PUBLIC INTEREST REVIEW FOR GROUND WATER APPLICATIONS

TO: Water Rights Section Date September 6, 2016
 FROM: Ground Water/Hydrology Section K. Lite
 SUBJECT: Application G- 18347 Reviewer's Name K. Lite
 Supersedes review of N/A Date of Review(s) _____

A. GENERAL INFORMATION: Applicant's Name: Root Orchards County: Wasco

G-18347: Lyle Quadrangle

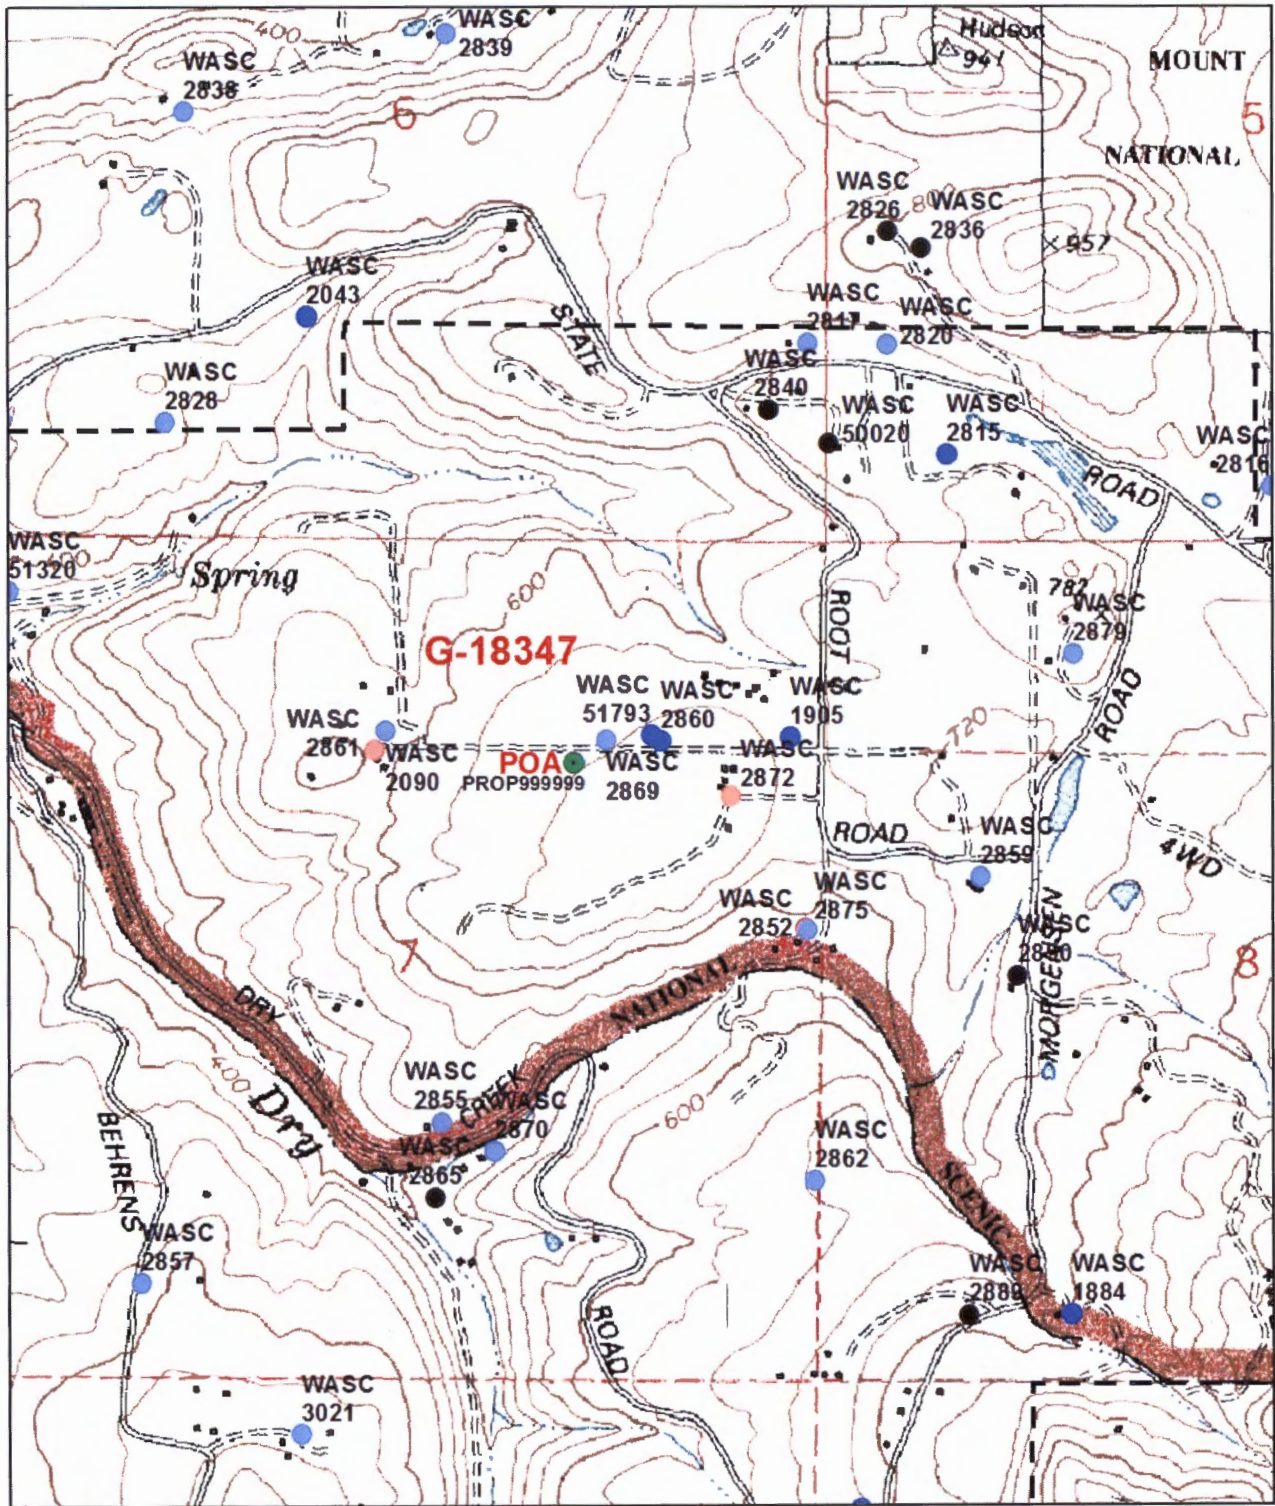
Basis for aquifer hydraulic connection evaluation: Dry Creek is a local sink for the upper basalt units aquifers. Grande Ronde Basalt aquifers are not hydraulically connected to Dry Creek.
